PLANNING AND DEVELOPMENT SERVICES STAFF REPORT

For Planning Commission Meeting of May 20, 2014

**SUBJECT: Bank of Ann Arbor Headquarters Addition Special Exception Use and Site Plan for City Council Approval
(125 South Fifth Avenue)
Project Nos. SP14-015 and SEU14-008**

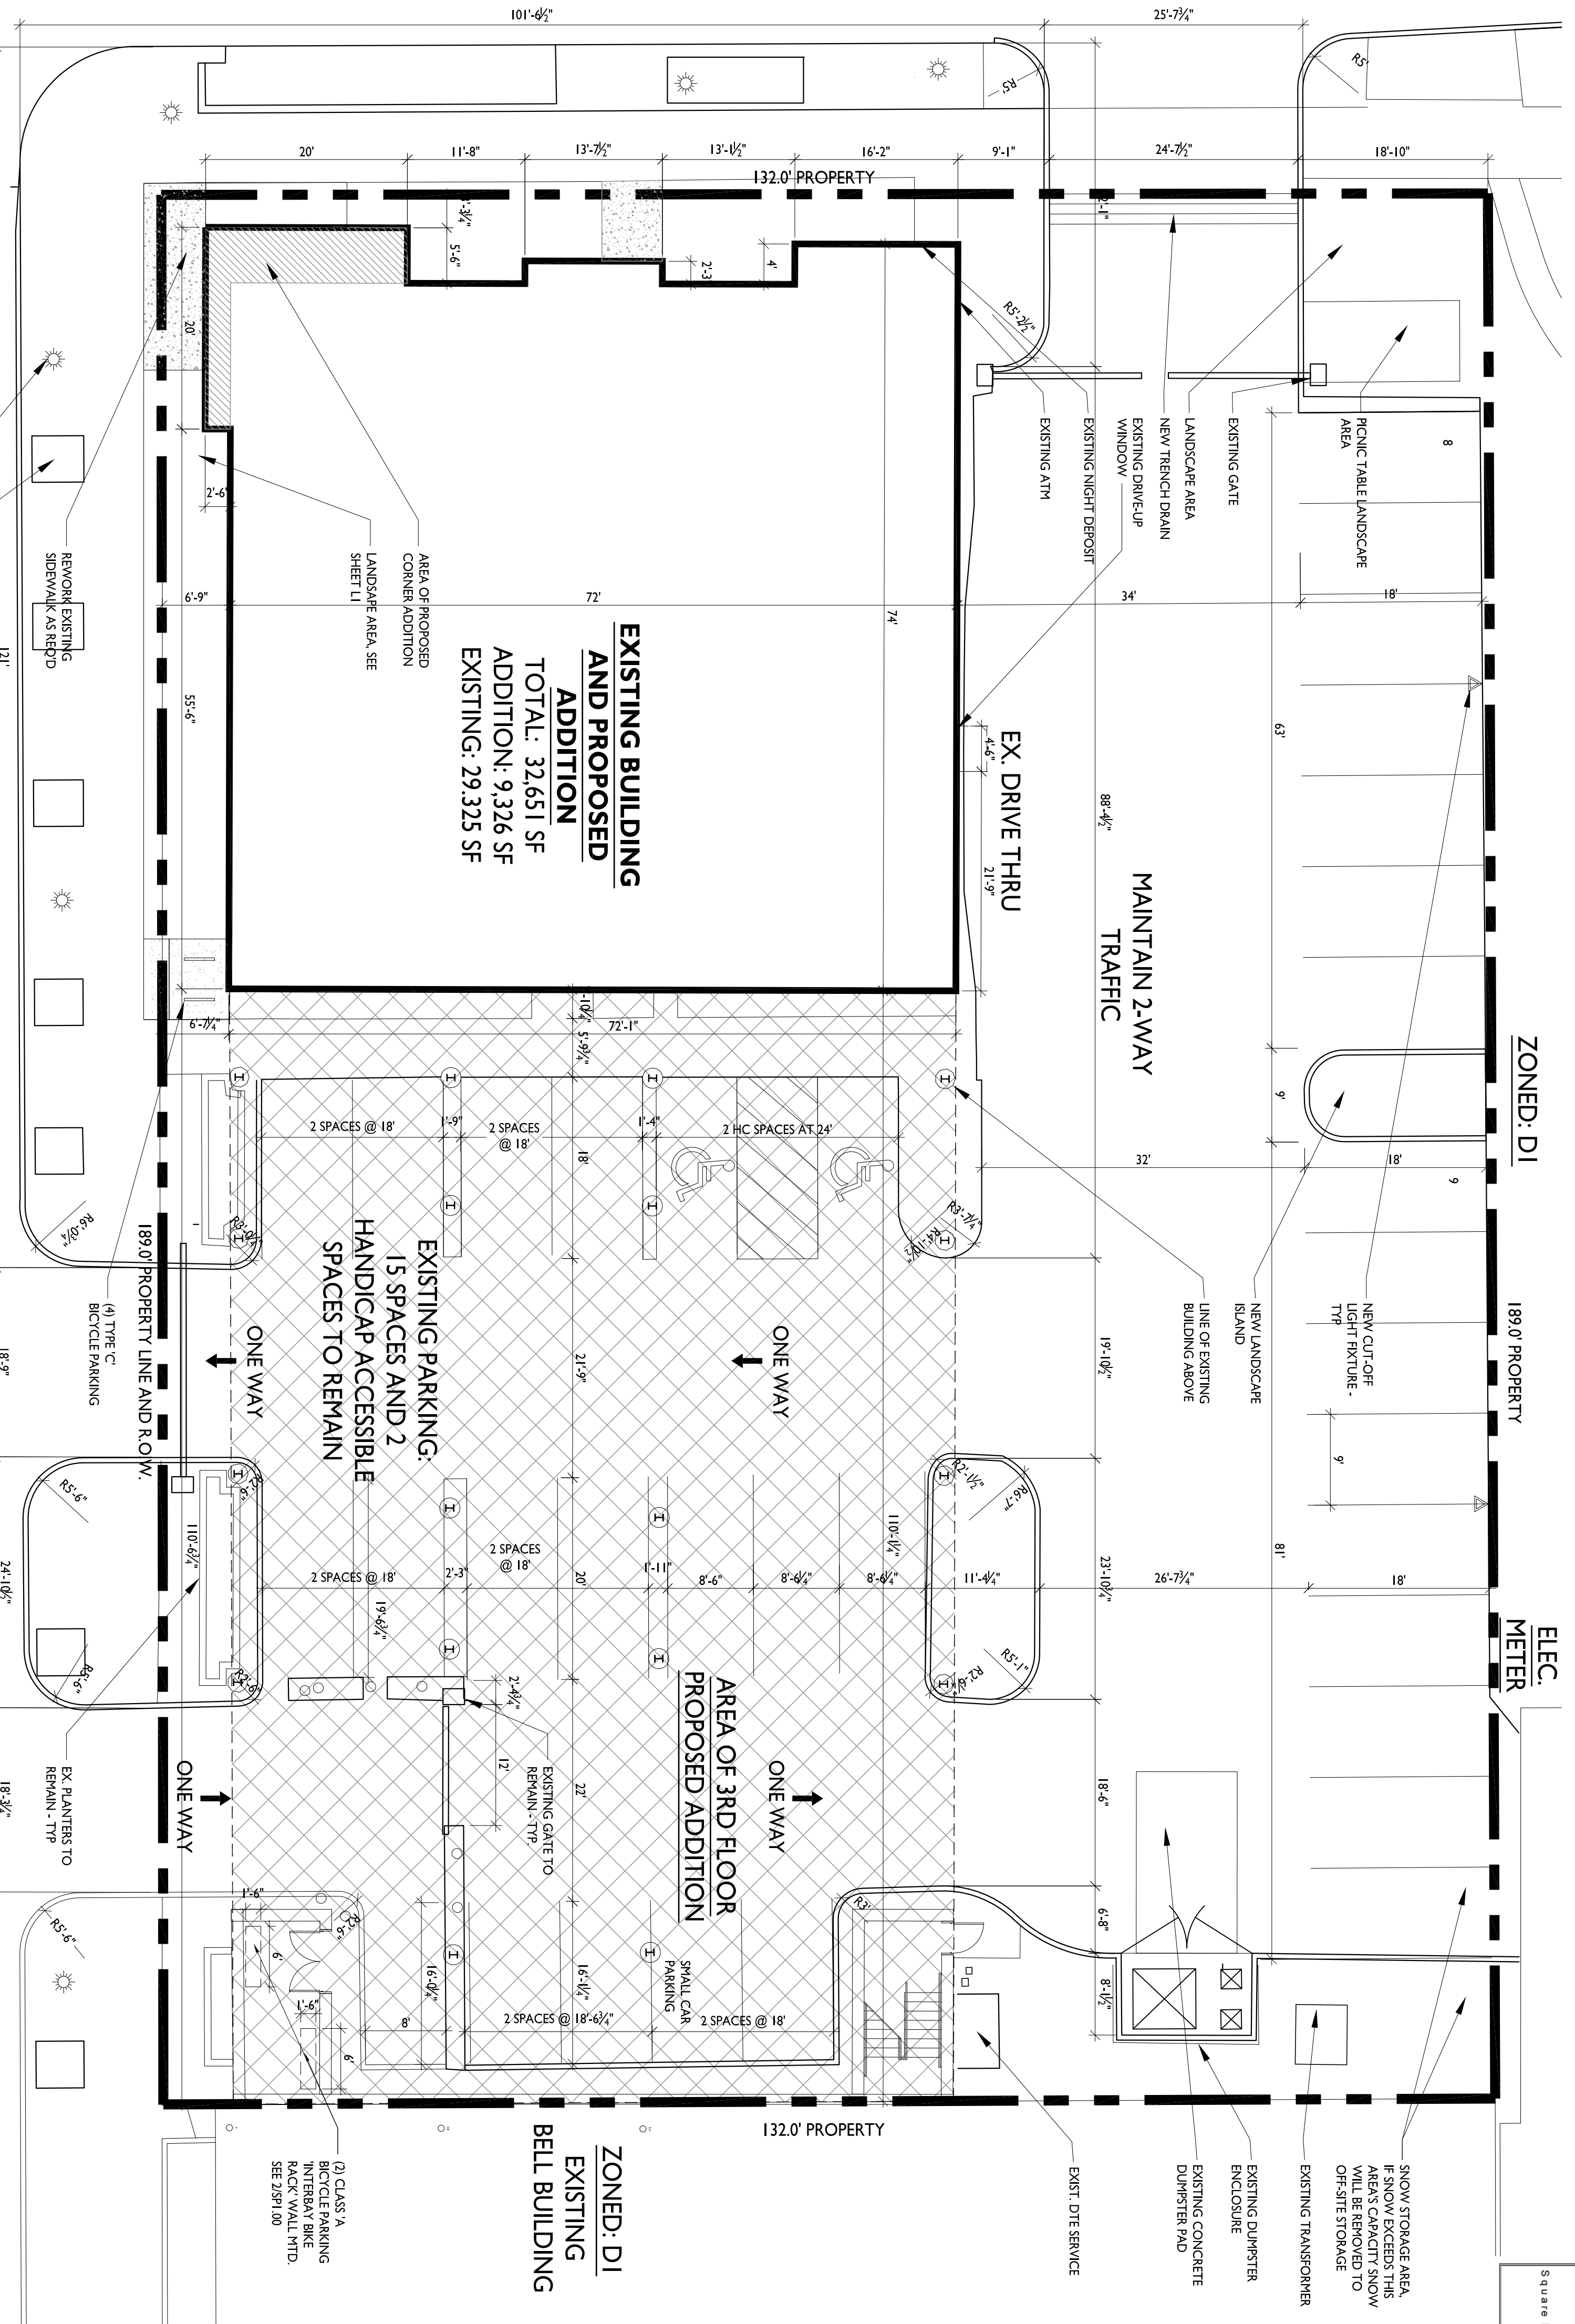
Forestry and Natural Resources – The proposed interior landscape island in the parking lot does not have a tree as required. A tree must be added to the proposed island, or the island must be relocated outside of the underground storm water detention system below, or another treed island must be proposed elsewhere to meet the maximum row of stalls requirement.
